V2500-A1/A5 SERIES PROPULSION SYSTEMS SERVICE BULLETIN

This document transmits Revision 5 to Service Bulletin V2500-ENG-71-0177

V2500-ENG-71-0177

ENGINE – POWERPLANT – EEC AND IGNITION SUPPLY HARNESS – THRUST REVERSER CONTROL VALVE
CABLES – REROUTE OF

Installation of cables and attaching hardware
Figure 1 Sheet 1 of 6

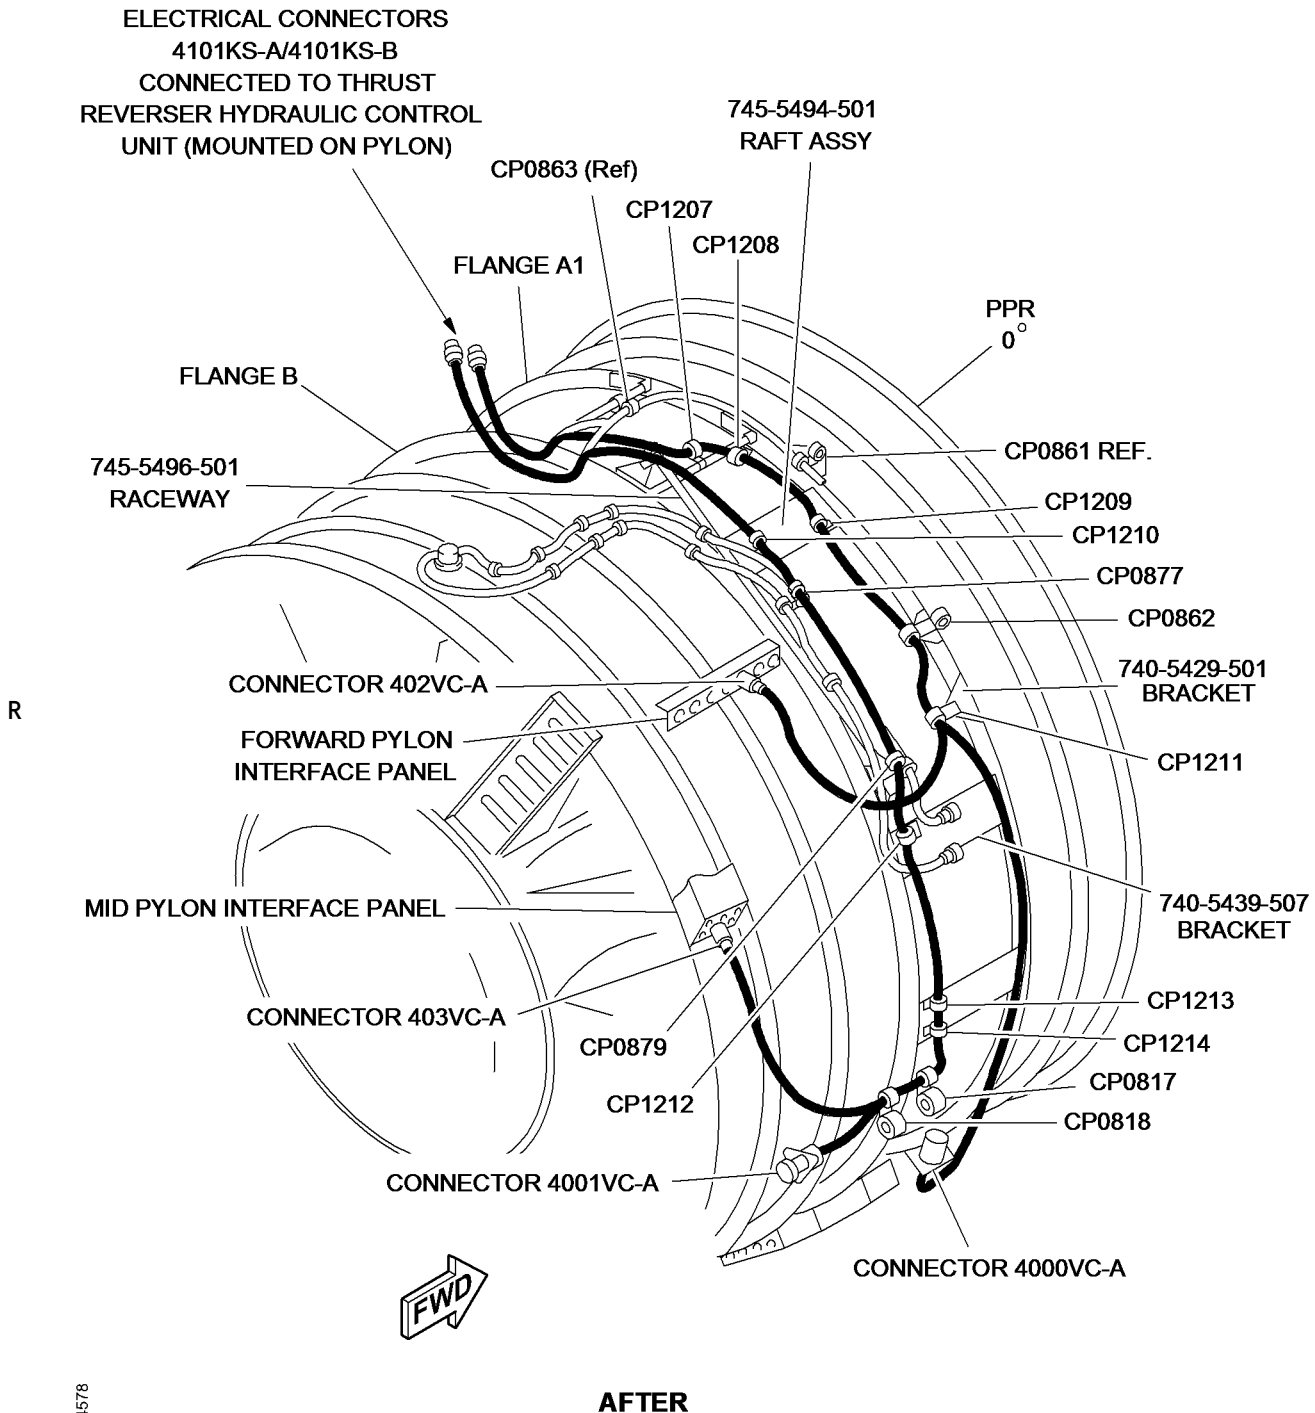
- (1) Cut and remove the lockwire from the screws, coupling nut and shell on the 4101KS-A connector as shown. (Refer to Figure 1 Sheets 1, 2 and 3).
- (2) Remove the screws and the strain relief clamp from the coupling nut as shown.

Installation of cables and attaching hardware
Figure 1 Sheet 2 of 6

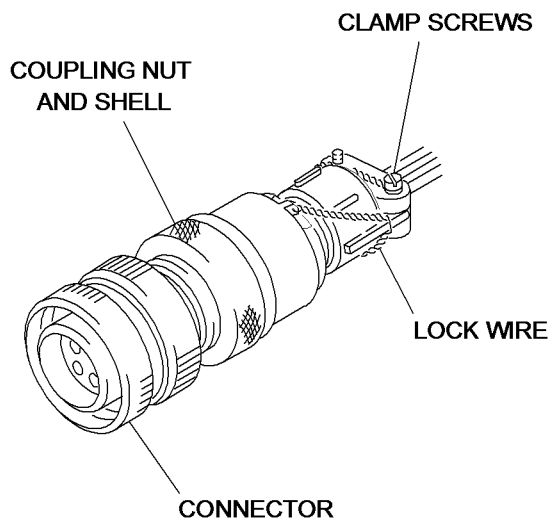
- (58) Route the new cables along the main harness as shown and tie with white lacing tape (CoMat 02-159). Refer to the Standard Practices and Processes Manual (SPP-V2500-1IA) Chapter 70-43-02 for details on harness lacing. (Refer to Figure 1 Sheet 2).
- (59) Remove the main harness ident sleeve and install the new TMS CM20 ident sleeve with two cable ties or lacing tape (CoMat 02-159).
- (60) Write the harness identification number on the new sleeve with a marking pen (CoMat 06-131).

- (11) Connect the 4101KS-A and 4101KS-B connectors to the Thrust Reverser control valve as shown. Hand tighten the couplings only. (Refer to Figure 1 Sheet 2).

Installation of cables and attaching hardware
Figure 1 Sheet 4 of 6

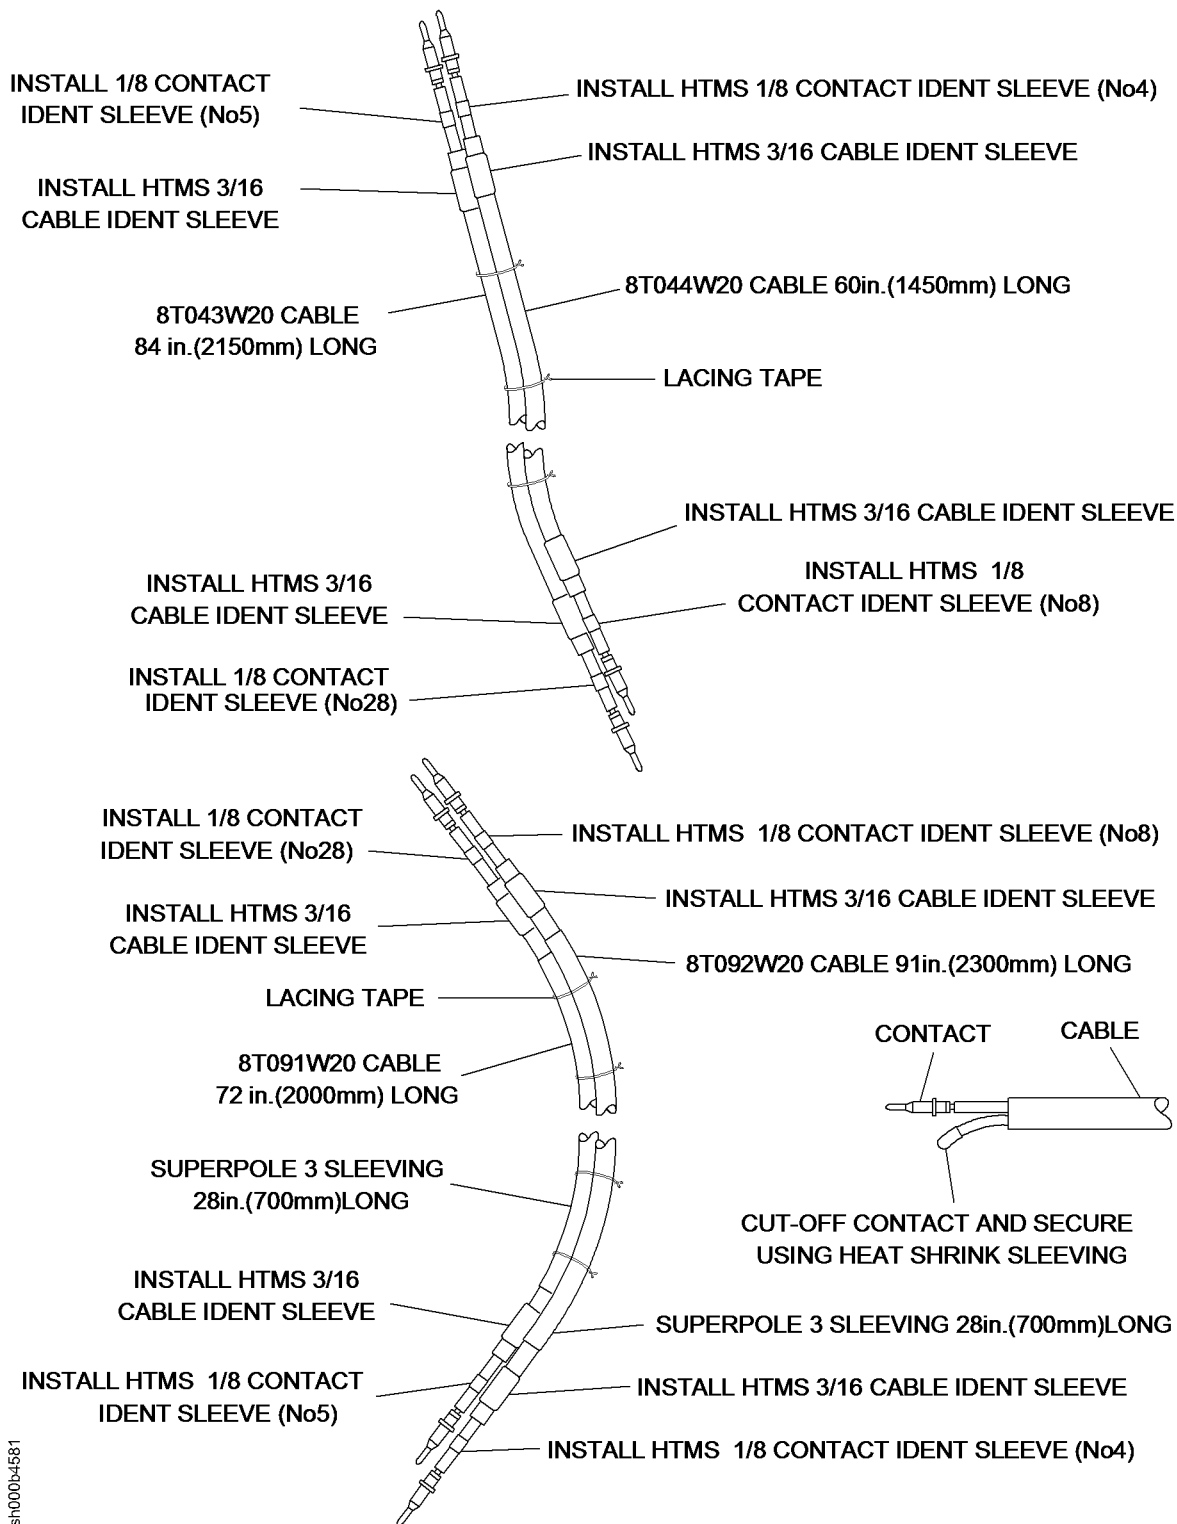
- (4) Remove contacts number 4 and 5 (cables 8T044W20 and 8T043W20) from the 4101KS-A connector as shown with the M81969/14-03 insertion/extraction tool (white end). (Refer to Figure 1 Sheet 4).

- (48) Install the 4000VC-A connector shell to the connector as shown with a BT-BS-611 or TG-70 strap wrench. Make sure the ground shields are an equal distance apart around the shell. (Refer to Figure 1 Sheet 4).

Installation of cables and attaching hardware
Figure 1 Sheet 5 of 6

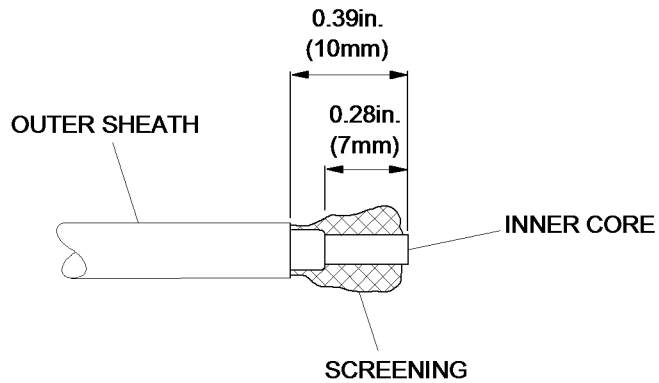
- (5) Cut off the contacts and cap the cables with heat shrink sleeving as shown. (Refer to Figure 1 Sheet 5).
- (6) Do steps 3.A. (1) thru (3) for the 402VC-A connector.

- (21) Locate and remove the old cable identification sleeves. Make sure you do not damage any of the cables in the harness.
- (22) Cut the new EJS26012-20F1 cable to the correct lengths as shown. (Refer to Figure 1 Sheet 5).
- (23) Cut two 28in. (700 mm.) lengths of superpole 3 sleeving as shown.
- (24) Put the superpole 3 sleeving on the new 8T092W20 and 8T091W20 cables as shown.
- (25) Tie the 8T091W20 and 8T092W20 cables together with white lacing tape (CoMat 02-159).
- (26) Install the new cable identification sleeves on the new cables as shown with a hot air gun to deliver air between 480 and 570 Degrees F. (250 and 300 Degrees C.).
- (27) Write the cable identification numbers on the new sleeves as shown with a marking pen (CoMat 06-131).

- (28) Install the new contact identification sleeves on the new cables as shown. (Refer to Figure 1 Sheet 5).
- (29) Remove the insulation from both ends of the new 8T092W20 cables as shown with an approved stripping tool so that the remaining insulation is against the aft end of the contact. Make sure that you can see the bare wire through the inspection hole in the contact. Do not cut or nick the wire. (Refer to Figure 1 Sheet 6).

Installation of cables and attaching hardware
Figure 1 Sheet 6 of 6

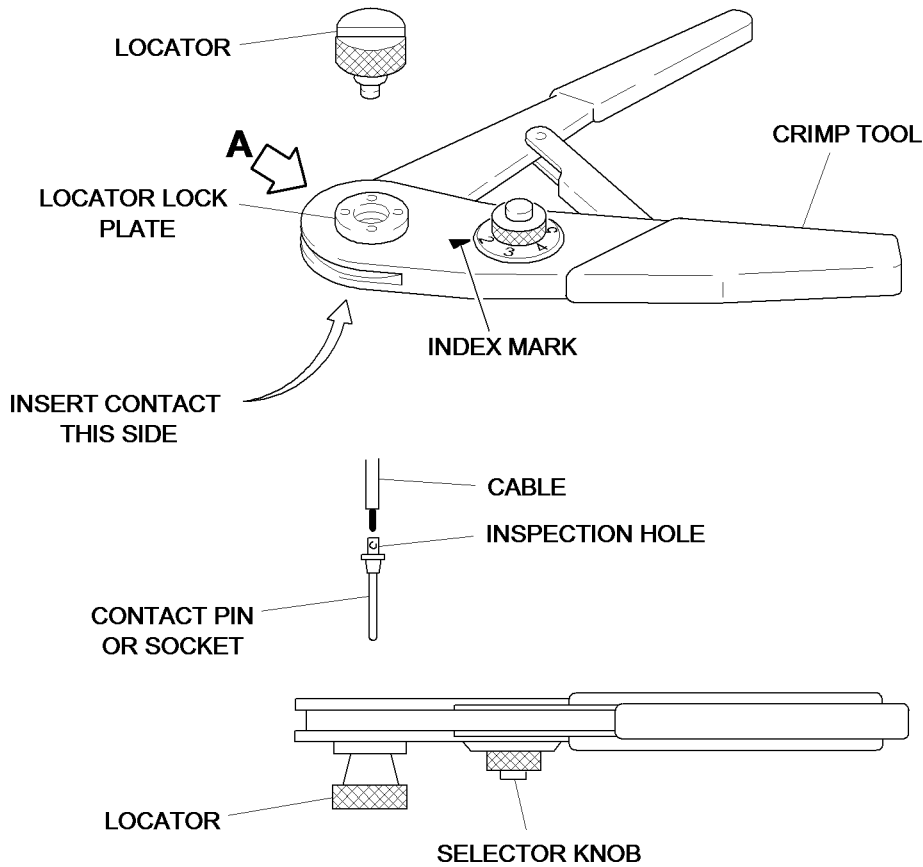
NOTE: The locator must be the correct size for the contact pin or socket.

Installation of brackets and clipping points
Figure 2 Sheet 1 of 11

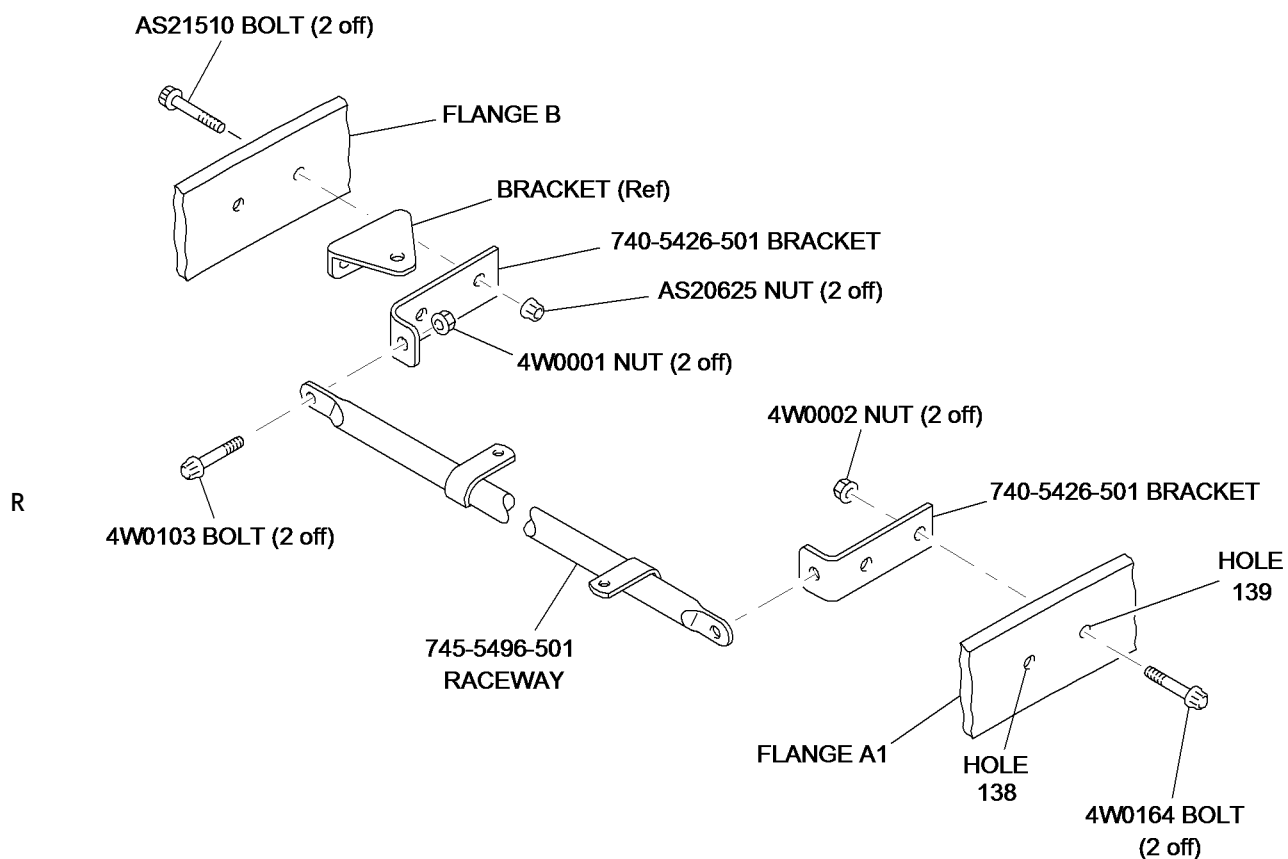
- R (1) Install the new 740-5426-501 Support Bracket on Flange 'B' as shown with two AS21510 Bolts and two AS20625 Nuts. (Refer to Figure 2 Sheet 1). Torque the bolts to 85 to 105 lbfin. (10 to 12 Nm).

- R (2) Install the new 740-5426-501 Support Bracket on Flange 'A1' as shown with two new 4W0164 Bolts and two new 4W0002 Nuts. Torque the bolts to 85 to 105 lbfin. (10 to 12 Nm).

- R (3) Install the new 745-5496-501 Raceway as shown with two new 4W0103 Bolts and two new 4W0001 Nuts. Torque the bolts to 36 to 45 lbfin. (4 to 5 Nm).

Installation of brackets and clipping points
Figure 2 Sheet 2 of 11

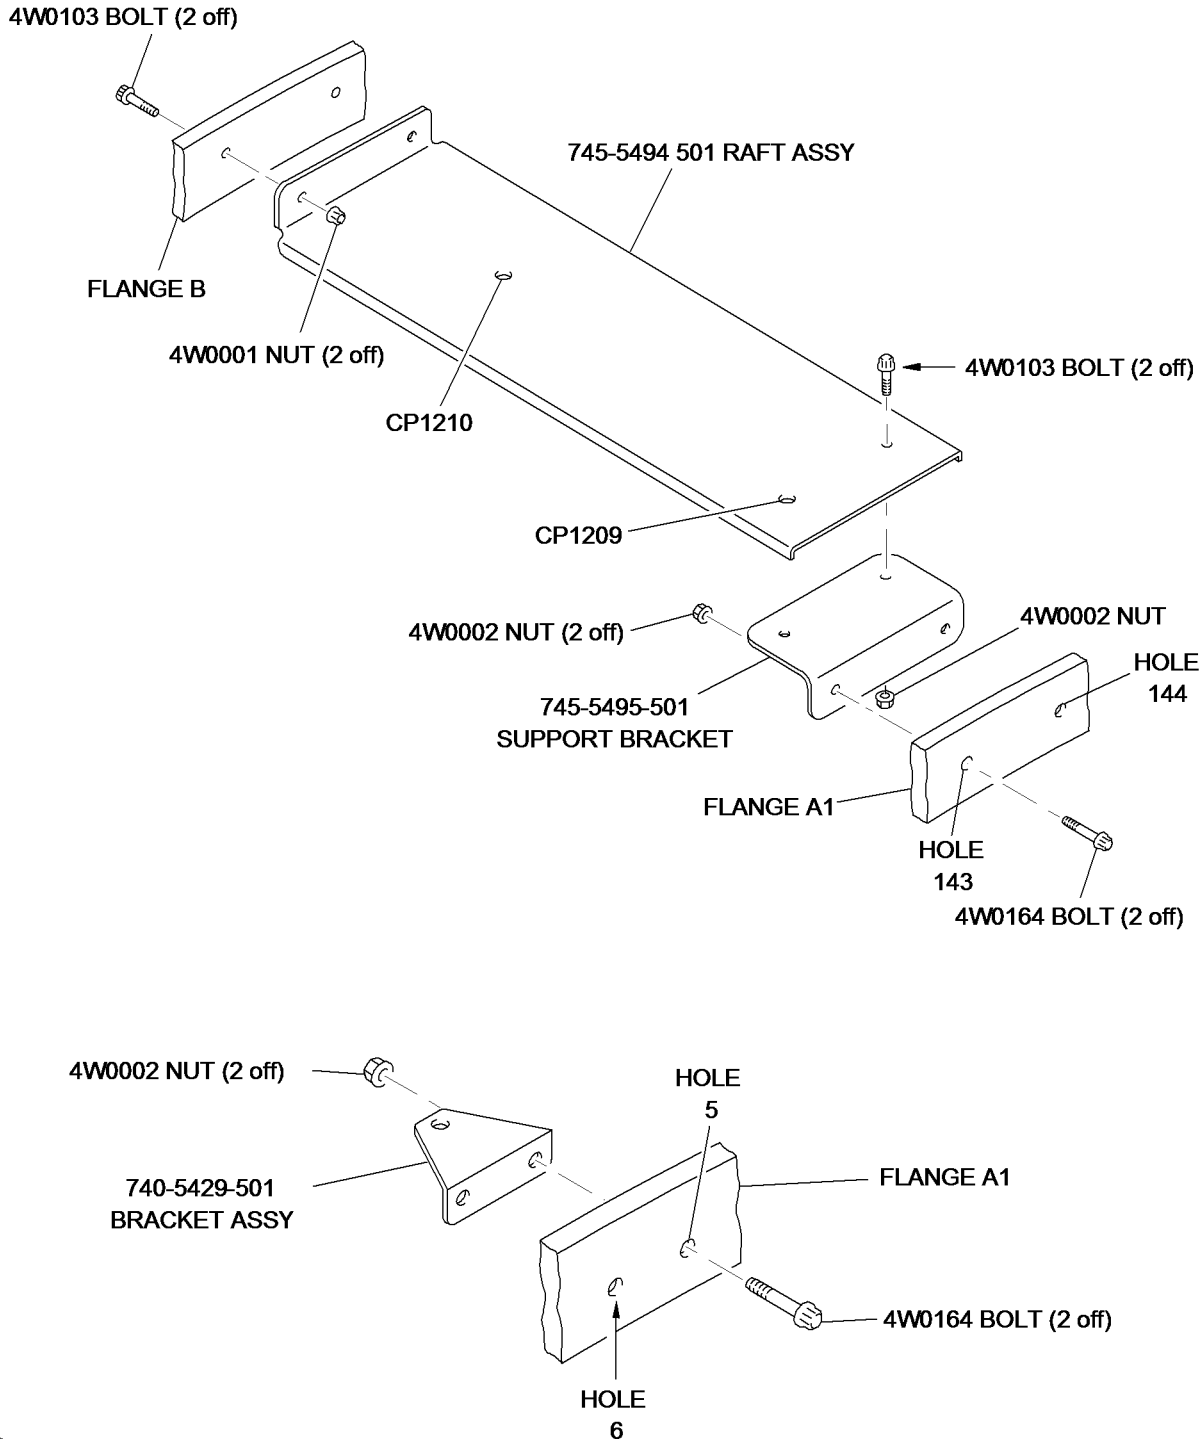
- R (4) Install the new 745-5495-501 Raft Support Bracket on Flange 'A1' as shown with two new 4W0164 Bolts and two new 4W0002 Nuts. (Refer to Figure 2 Sheet 2). Torque the bolts to 85 to 105 lbfin. (10 to 12 Nm).

- R (5) Install the new 745-5494-501 Raft Assembly to the new 745-5495-501 Support Bracket as shown with a new 4W0103 Bolt and a new 4W0002 Nut. Torque the bolt to 36 to 45 lbfin. (4 to 5 Nm)(Refer to Figure 2 Sheet 2).

- R (6) Install the other end of the new 745-5494-501 Raft Assembly to Flange 'B' as shown with two new 4W0103 Bolts and two new 4W0001 Nuts. Torque the bolts to 36 to 45 lbfin. (4 to 5 Nm).

Installation of brackets and clipping points
Figure 2 Sheet 5 of 11

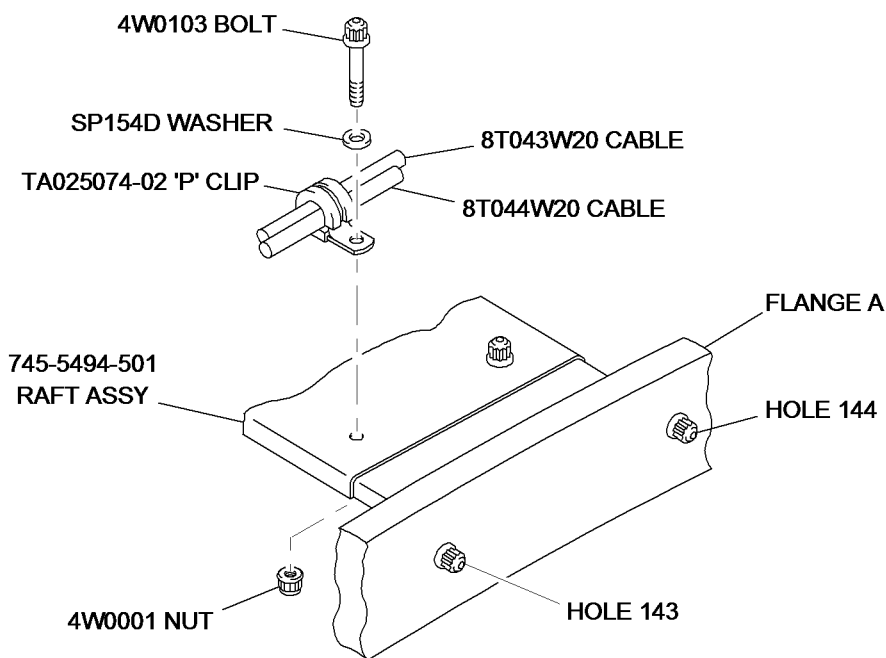
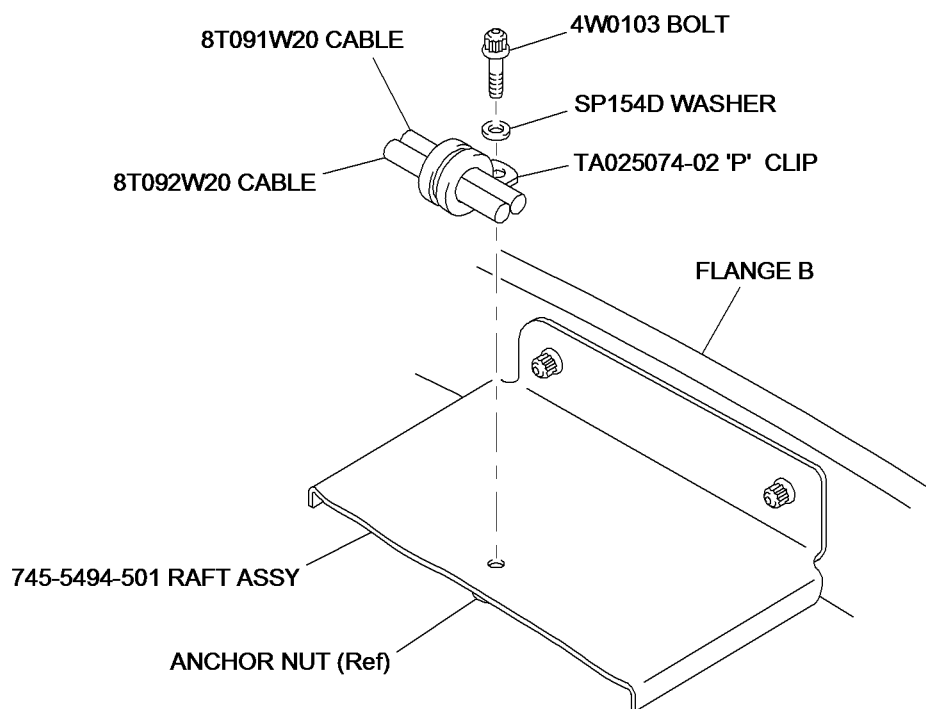
- (17) Install new clipping point CP1208 as shown with a new AS20624 Nut, AS21411 Bolt, SP154D Washer, ST1698D47 Spacer and a TA025074-02 'P' Clip.
- (18) Install new clipping point CP1209 as shown with a new 4W0103 Bolt, SP154D Washer, and a TA025074-02 'P' Clip. (Refer to Figure 2 Sheet 5).

- (19) Install new clipping point CP1210 as shown with a new 4W0103 Bolt, SP154D Washer and a TA025074-02 'P' Clip.
- (20) Install clipping point CP0877 as shown with a new TA025074-02 'P' Clip. (Refer to Figure 2 Sheet 6).

Installation of brackets and clipping points
Figure 2 Sheet 9 of 11

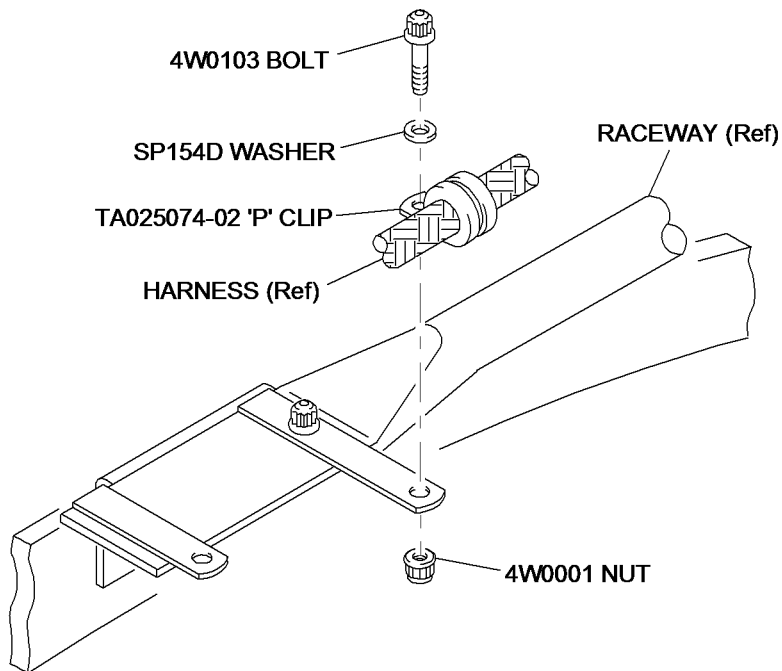
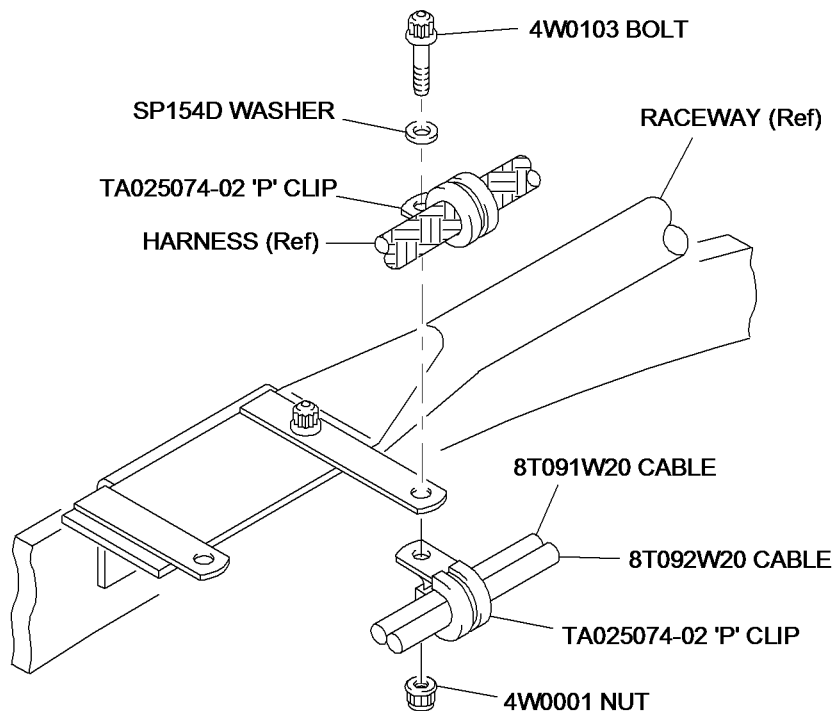
- (23) Install clipping point CP0879 as shown with a new TA025074-02 'P' Clip. (Refer to Figure 2 Sheet 9).
- (24) Install new clipping point CP1212 as shown with a new 4W0106 Bolt, SP154D Washer, ST1698D47 Spacer and a TA025074-02 'P' Clip. (Refer to Figure 2 Sheet 10).
